A/E Firm: WRA Architects		PM Firm: CBRE Vanir JV	Date: 12-10-2025
Org #: 159	School Name: L.L. Hotchkiss Elementary School	Bid Pack #/ CSP#: 207325	Addendum #: 1

**DALLAS INDEPENDENT SCHOOL DISTRICT
PROCUREMENT SERVICES
ADDENDUM NO. 1
CSP 207325 – L.L. Hotchkiss Elementary School - Renovation**

The Purpose of this Addendum No. 1 is to provide an alternate bid and updated the drawings and specifications:

3 Marquee Sign Section
1/2" = 1'-0"

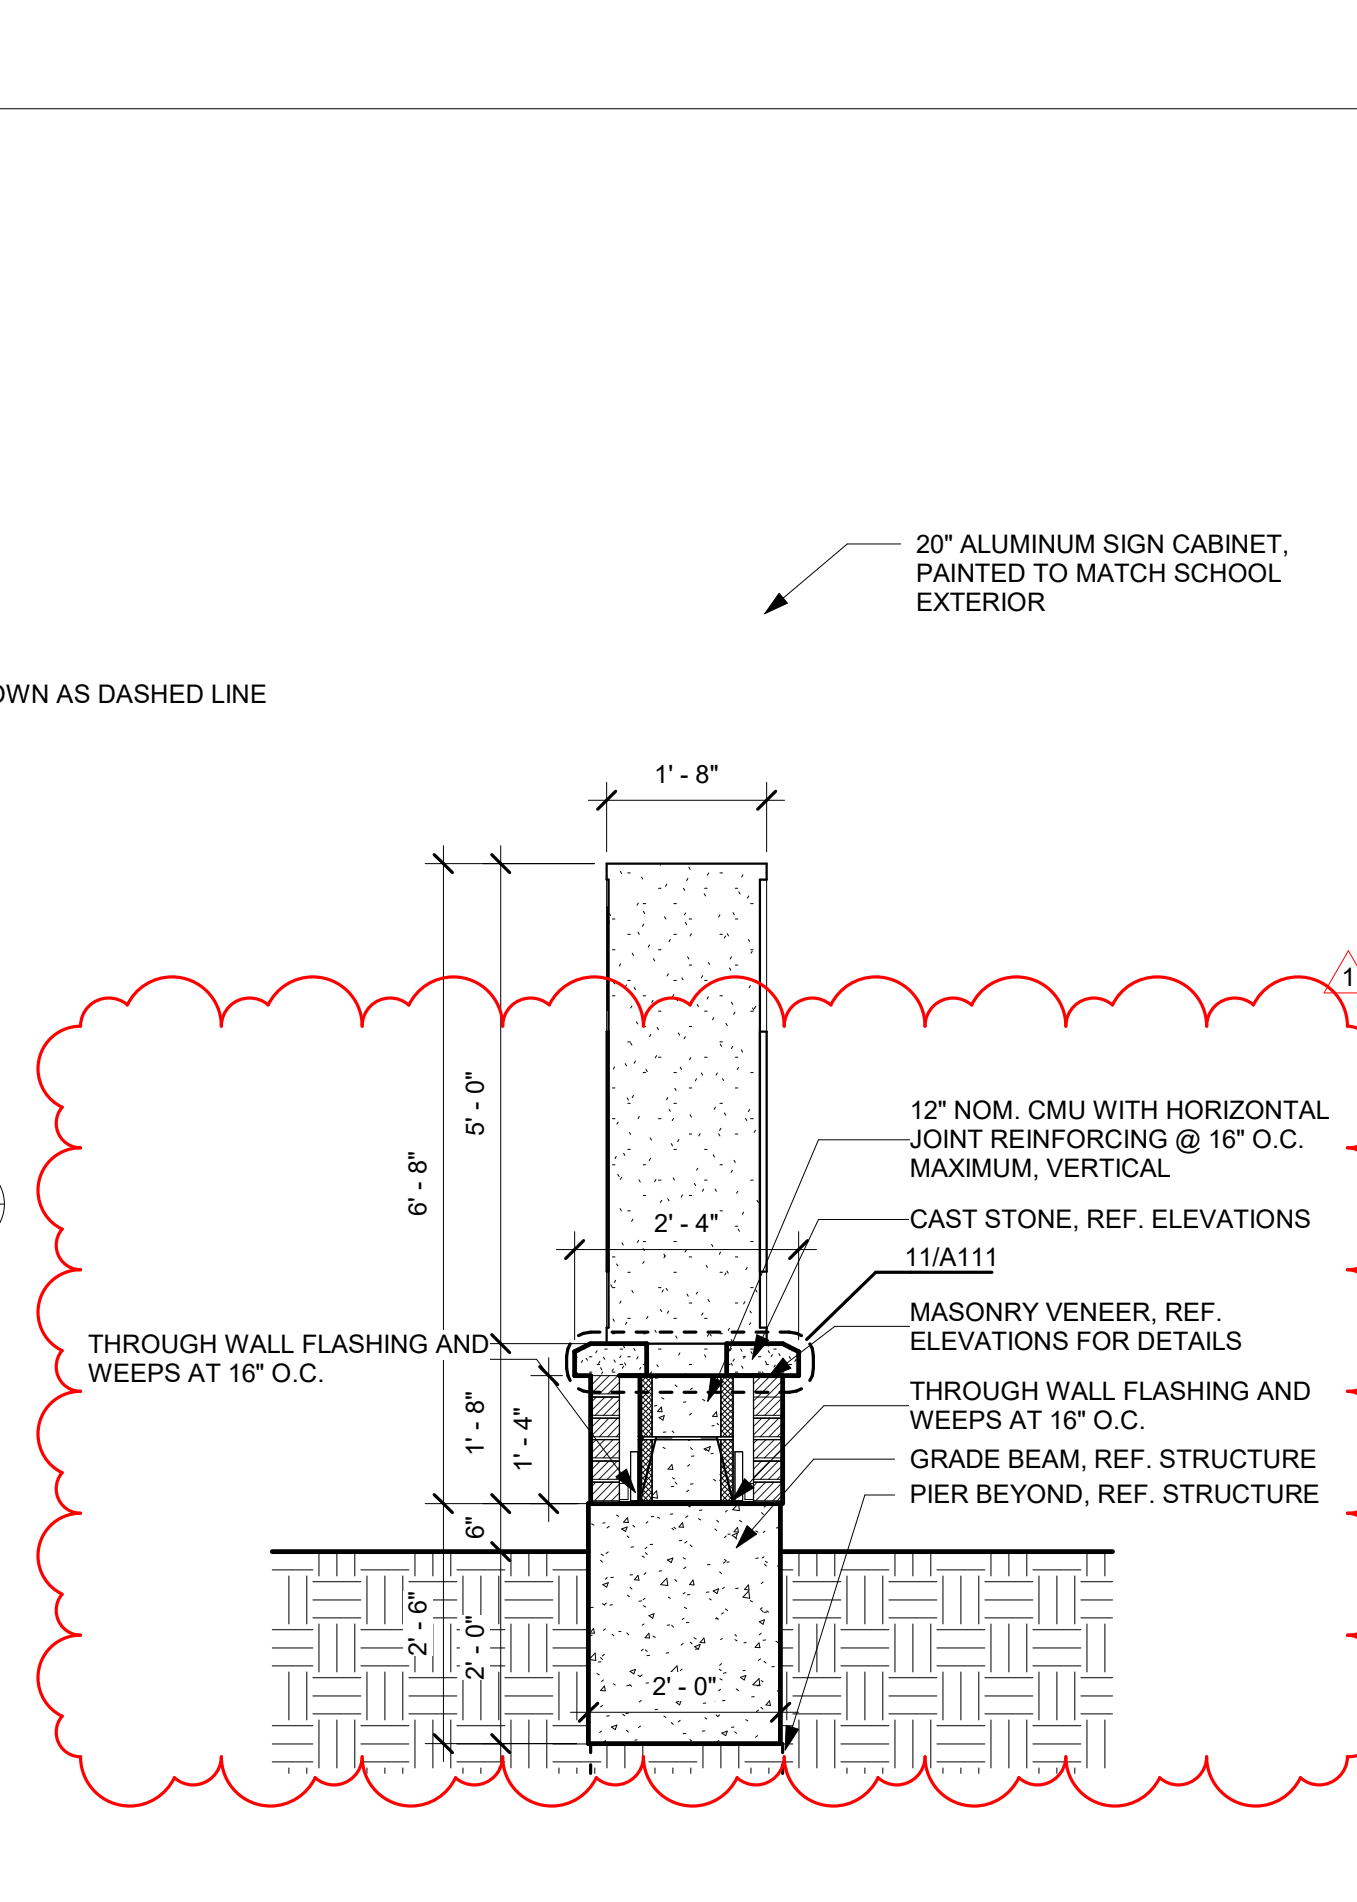
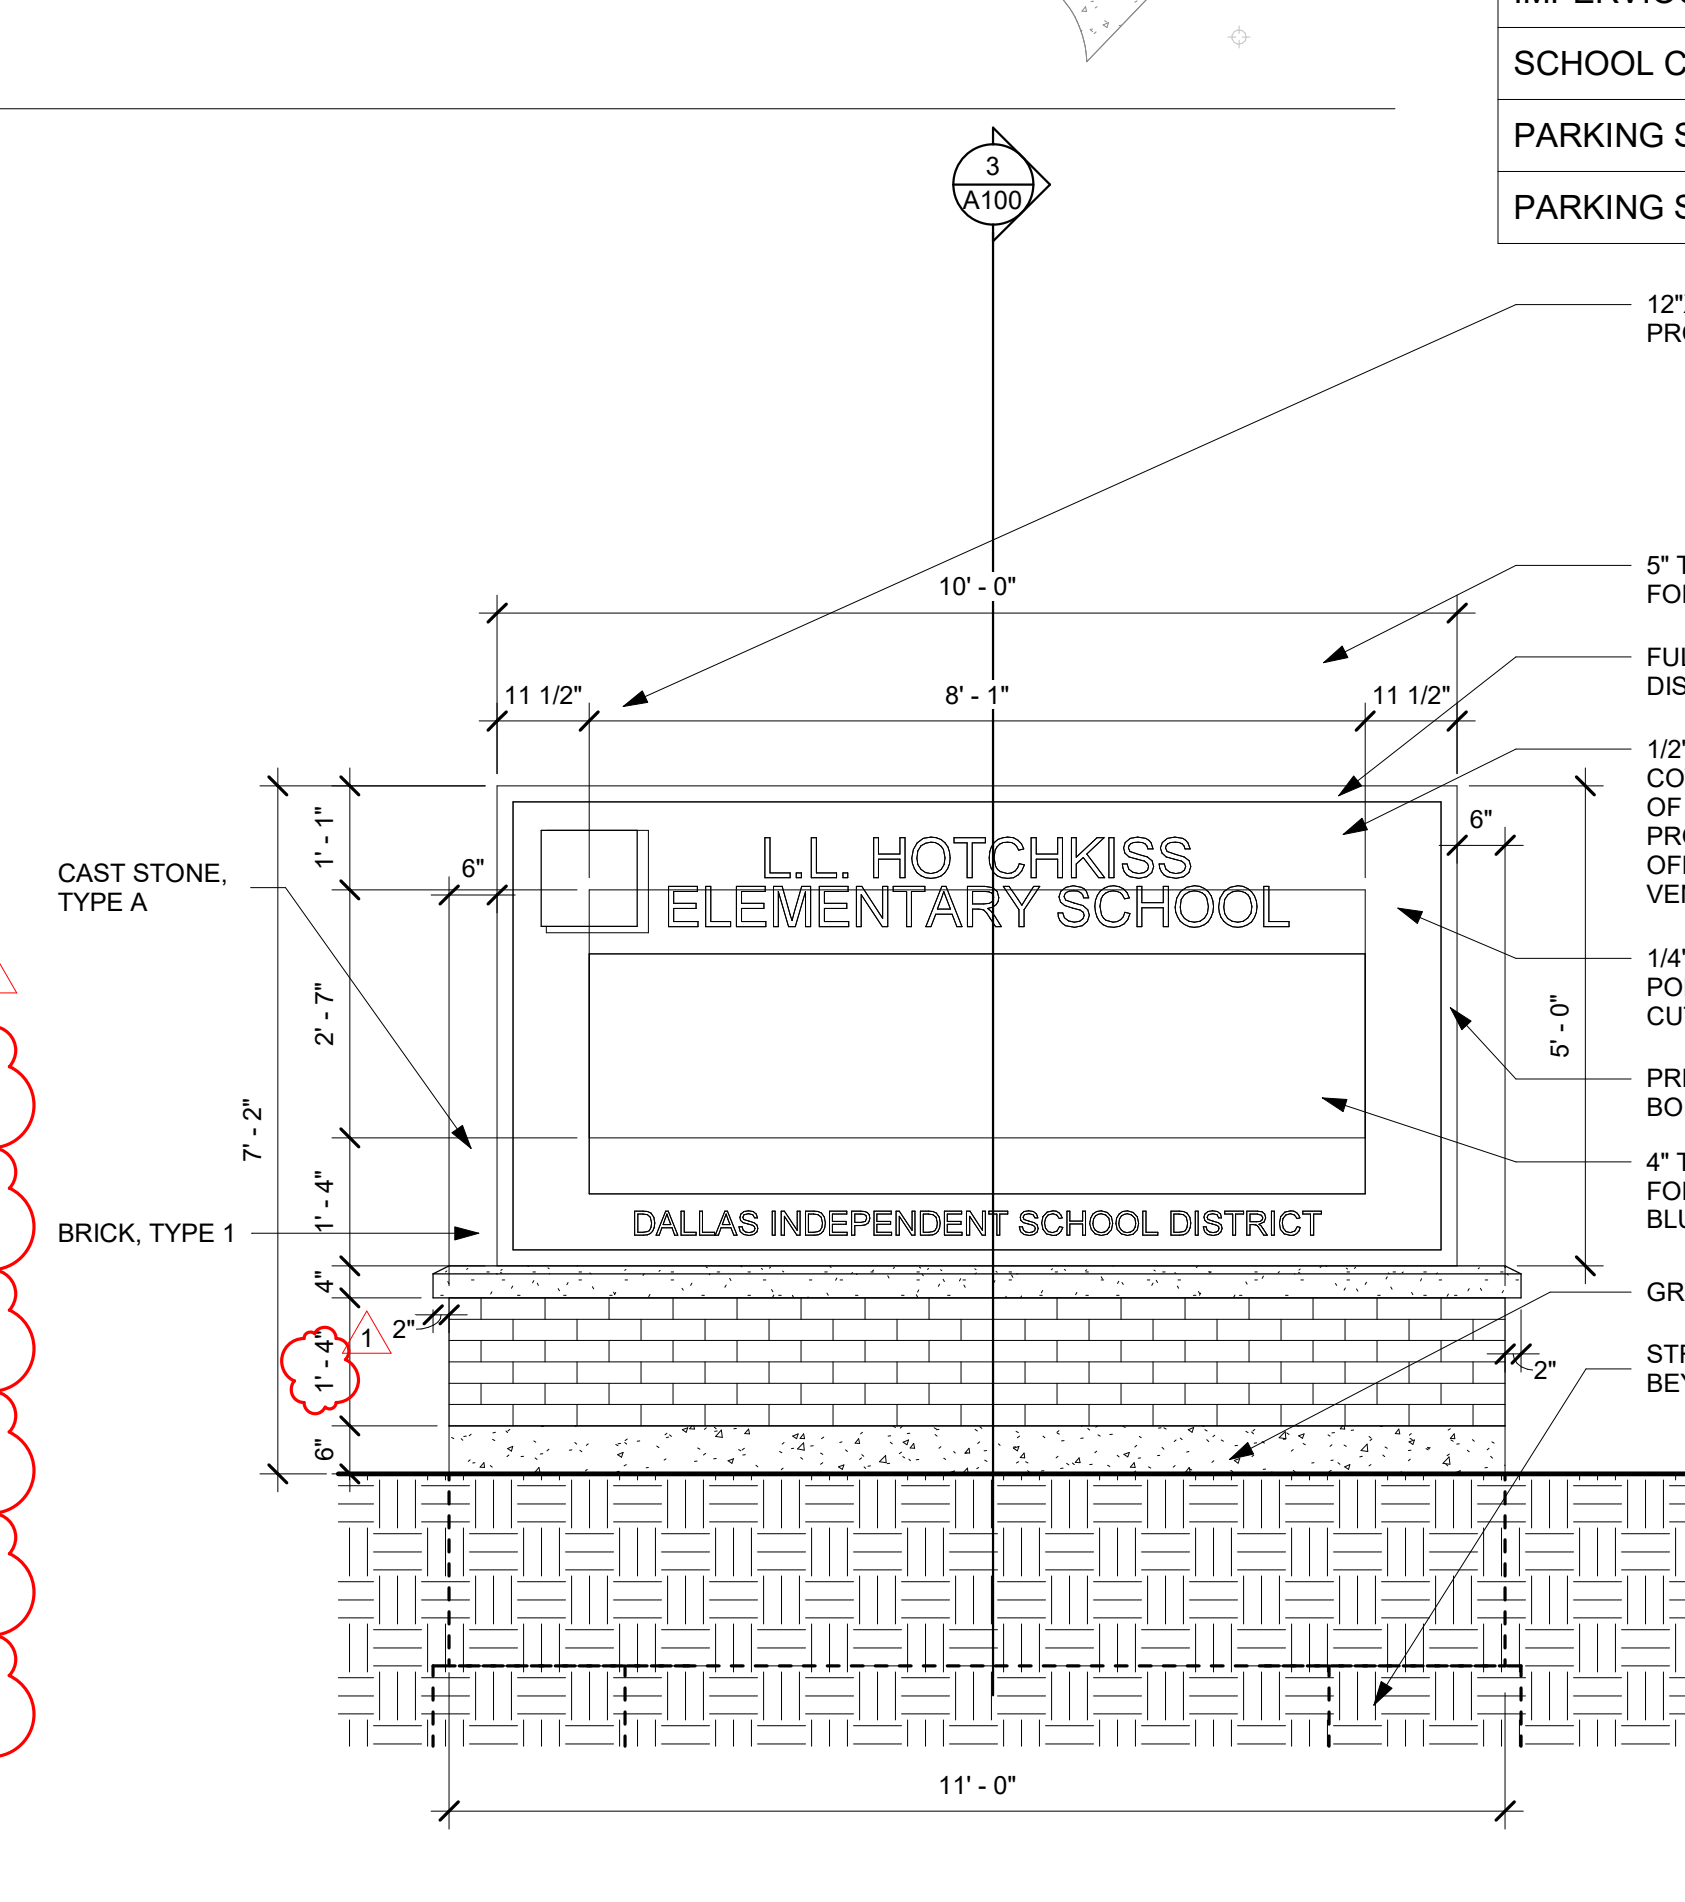
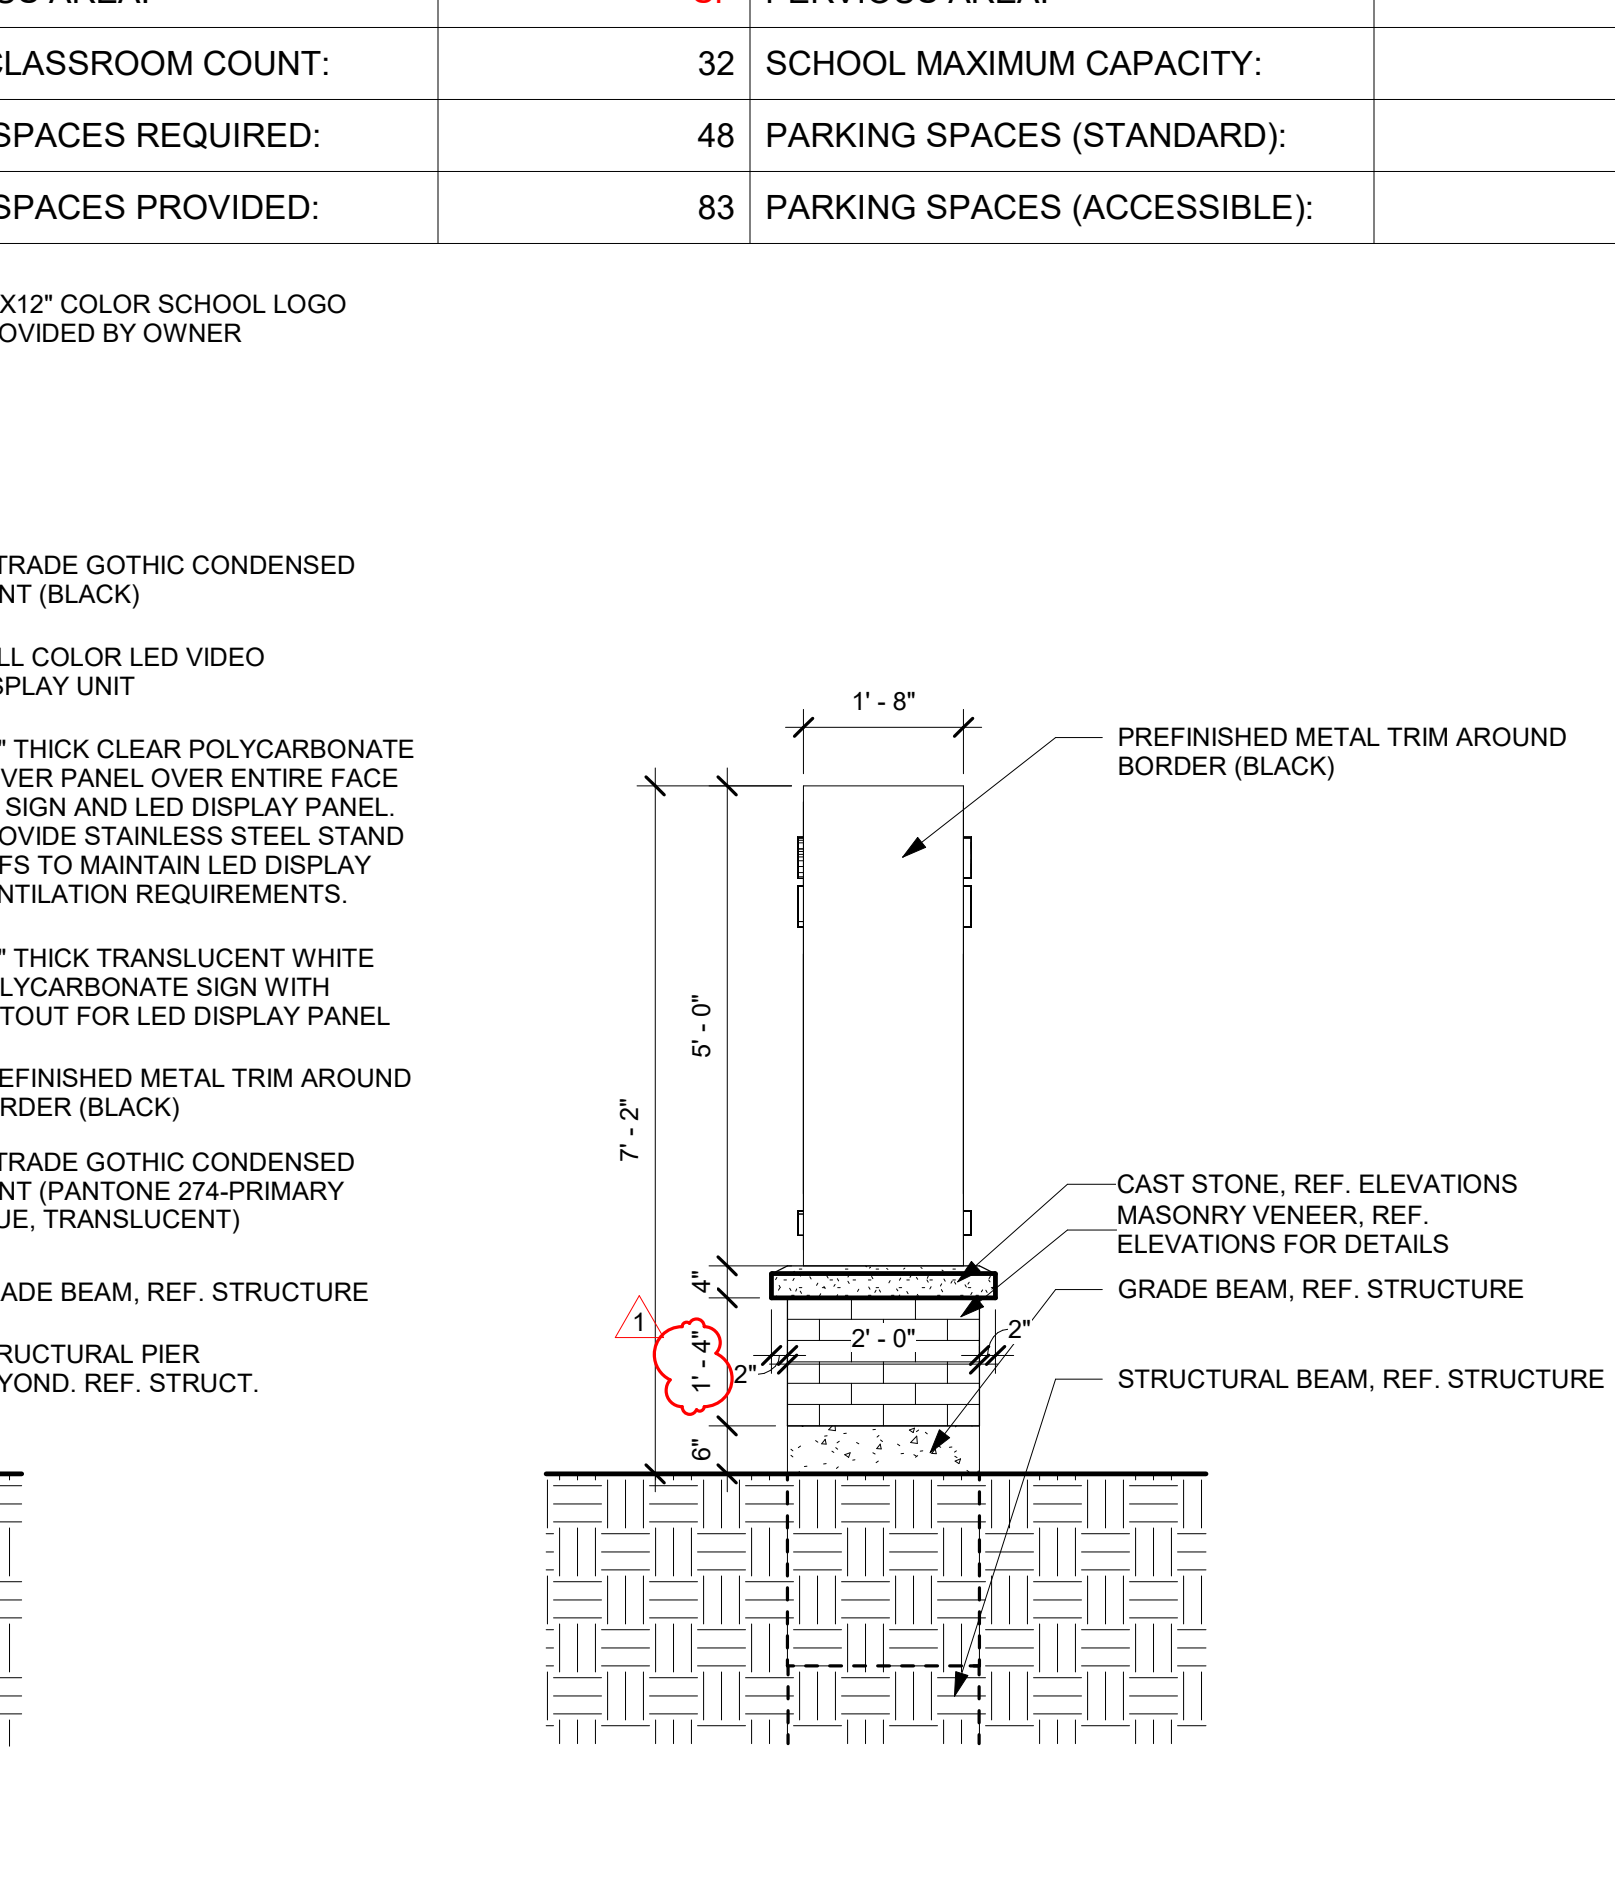
- A. CLARIFIED** no portables on existing site conditions
- B. REVISED** height of marquee masonry Detail 3, 4, 5 of A100
- C. REVISED** dimensions to detail 6/A100
